HITCH RACK RANCH QUARRY

M-2017-049

Subject: Responses to Preliminary Review of 112 Permit Application for Transit Mix Concrete Company, Hitch Rack Ranch Quarry, M-2017-049

RESPONSES TO FILING DEFICIENCIES ON HITCH RACK RANCH QUARRY PERMIT APPLICATION M-2017-049

EXHIBIT B INDEX MAP

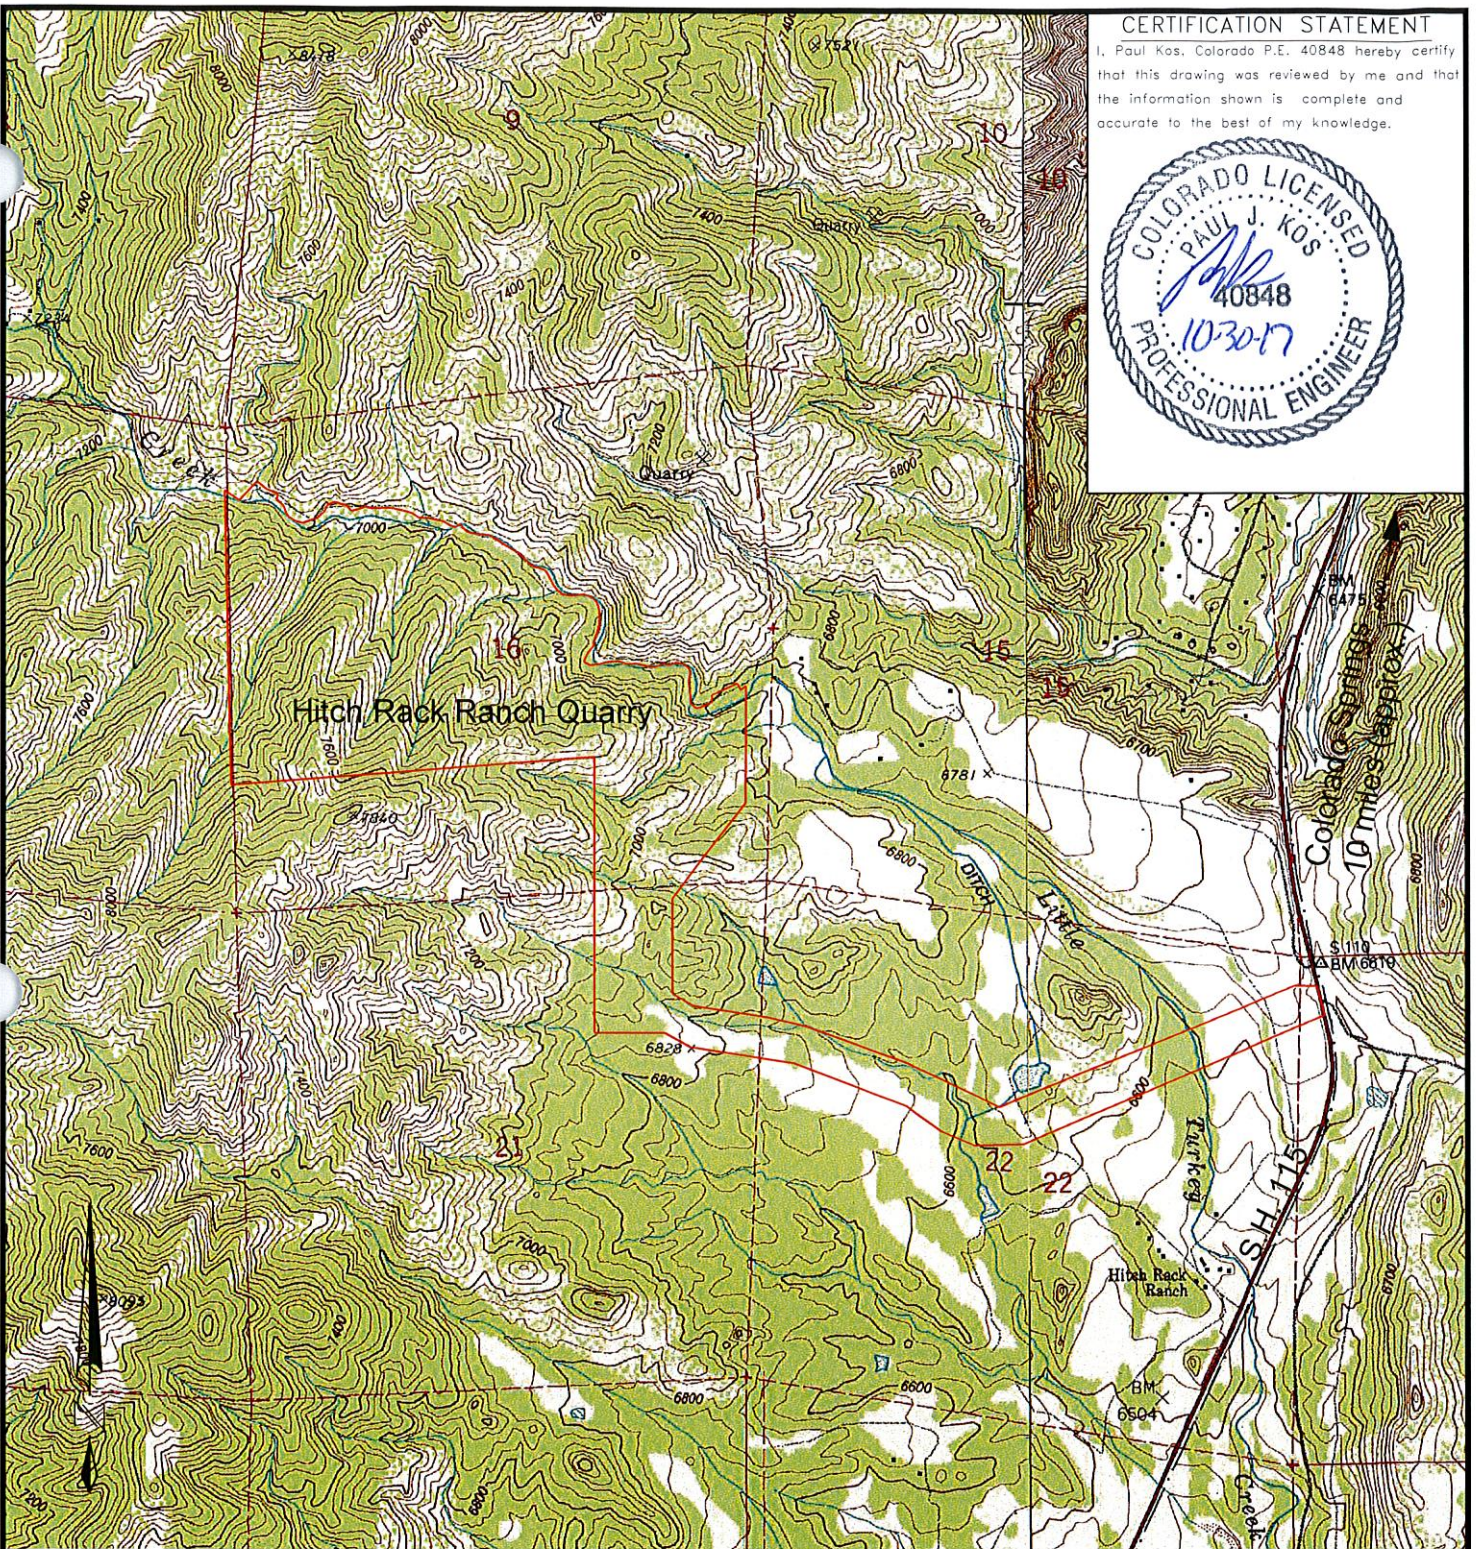
- 6) **Comment:** To better show the regional location of the affected land, please indicate on the index map the location of the nearest city, Colorado Springs, in relation to the proposed affected lands.
- 7) **Comment:** Please label Highway 115 on the index map.
- 8) **Comment:** Please enhance the proposed permit boundary on the index map for clear reference.

Responses to Items 6, 7, and 8: The map has been revised to address these comments.

**FIGURE G-14
HITCH RACK RANCH
TYPICAL DITCH DESIGNS**

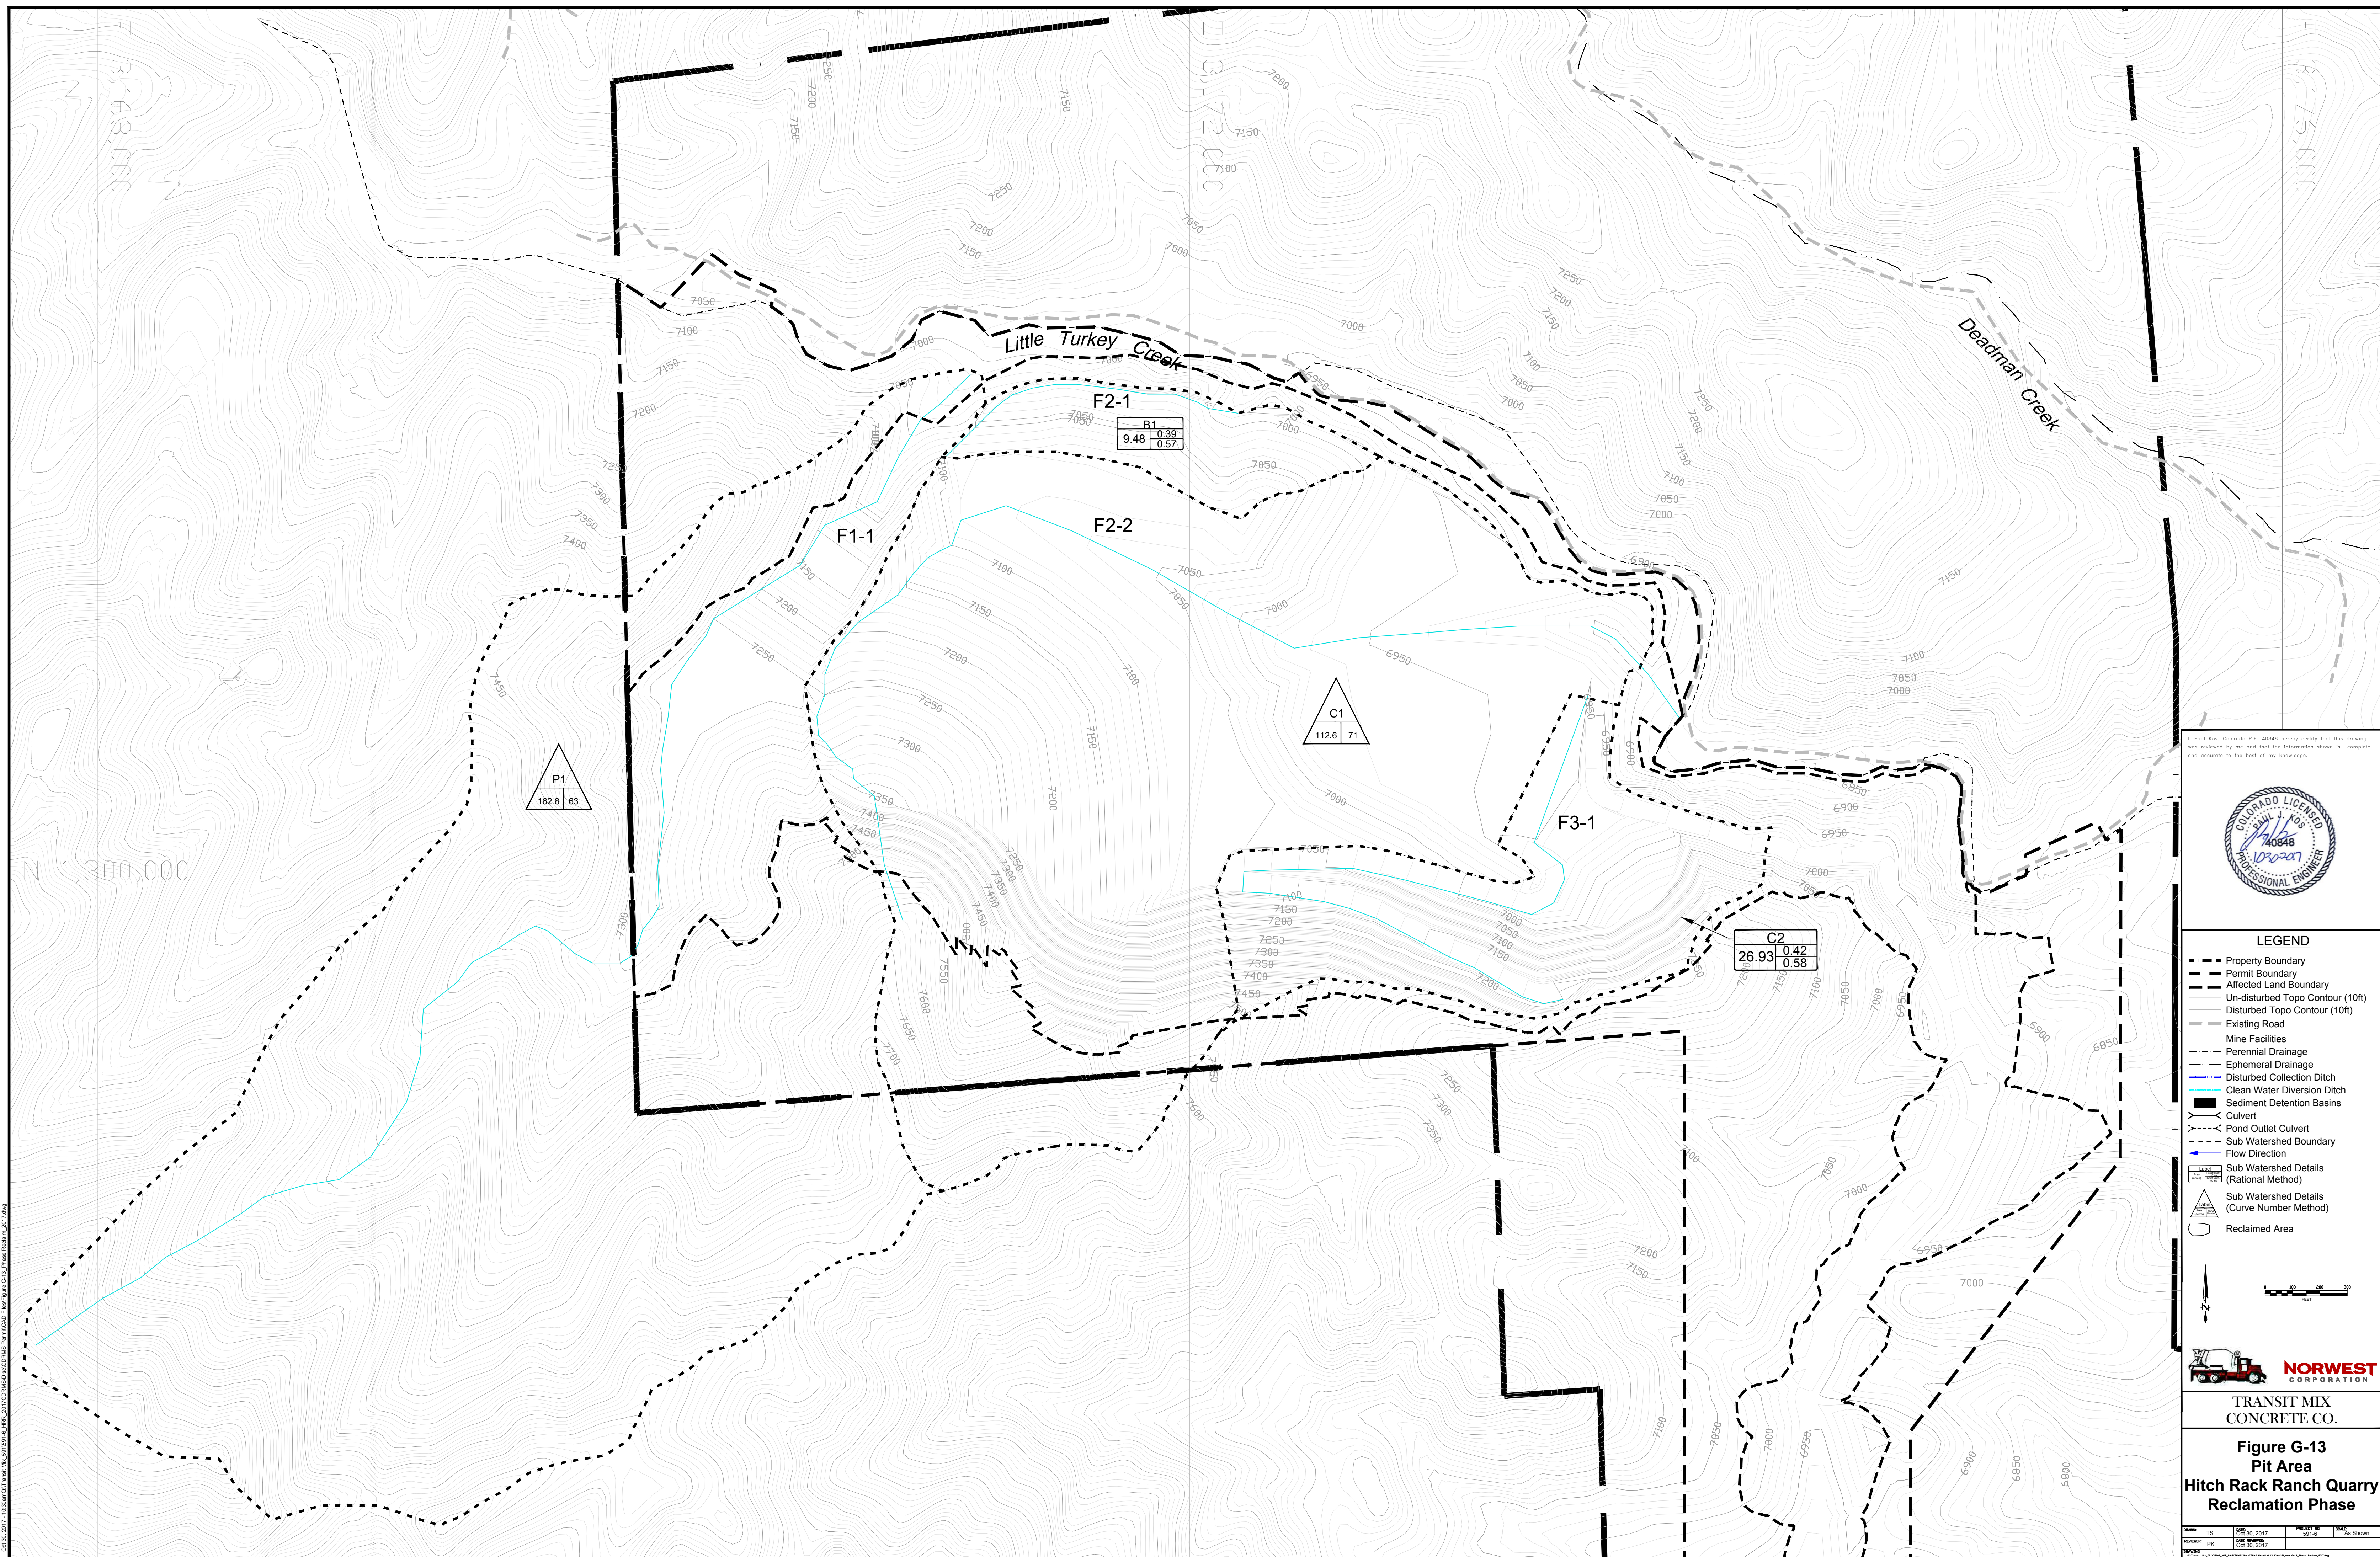
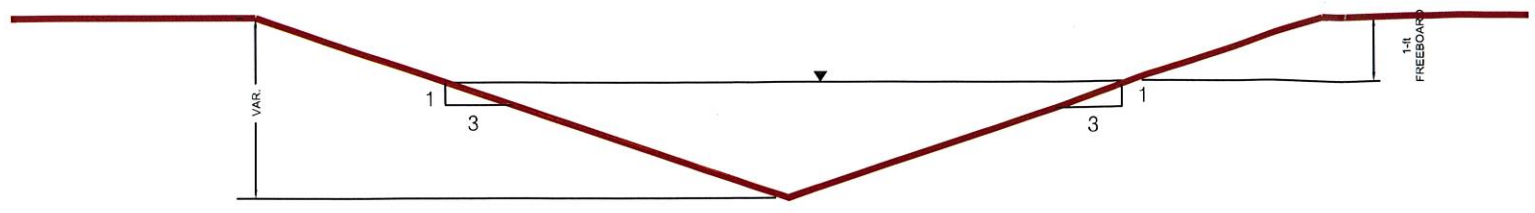
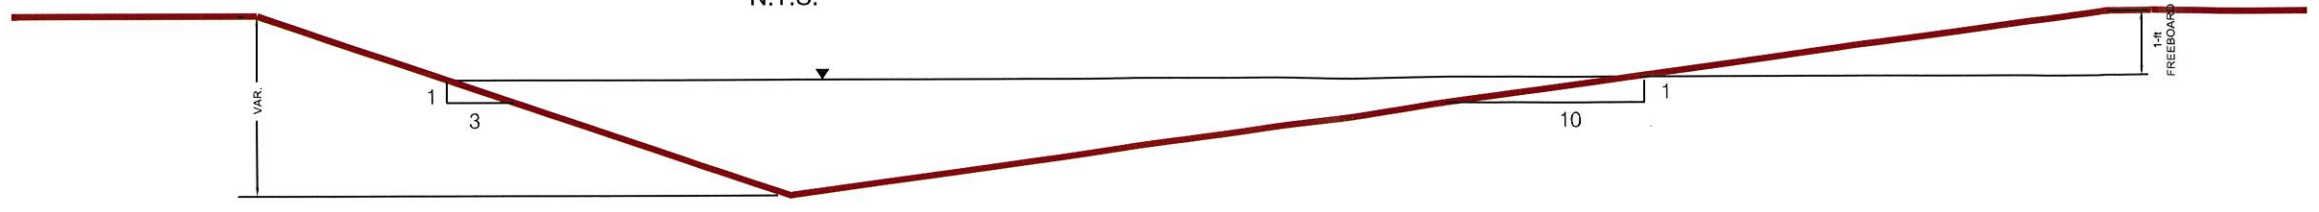
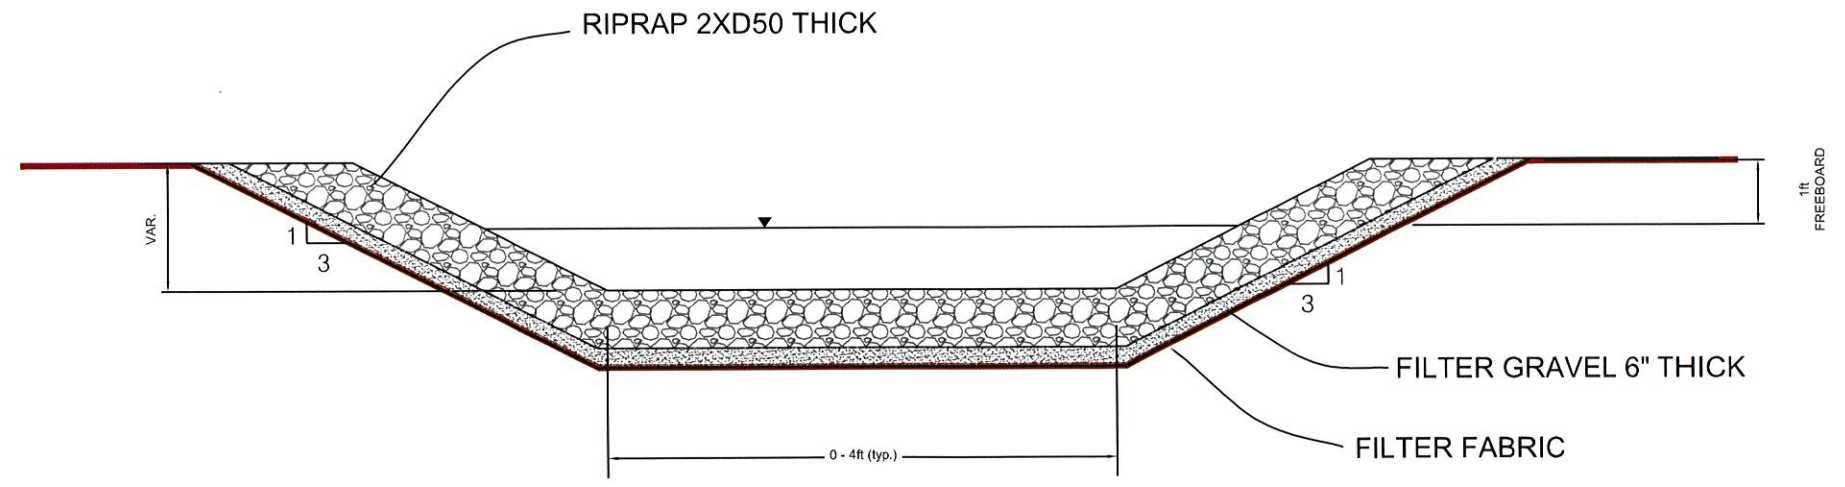
- 13) **Comment:** One of the copies of the application, Copy 1, Volume 1 of 2, includes an uncertified version of Figure G-14 – Typical Ditch Designs. Please submit a certified copy of Figure G-14 with the appropriate signature as necessary to satisfy the requirements of Rule 6.2.1(2)(b).

Response: A certified copy of Figure G-14 is included with this submittal.
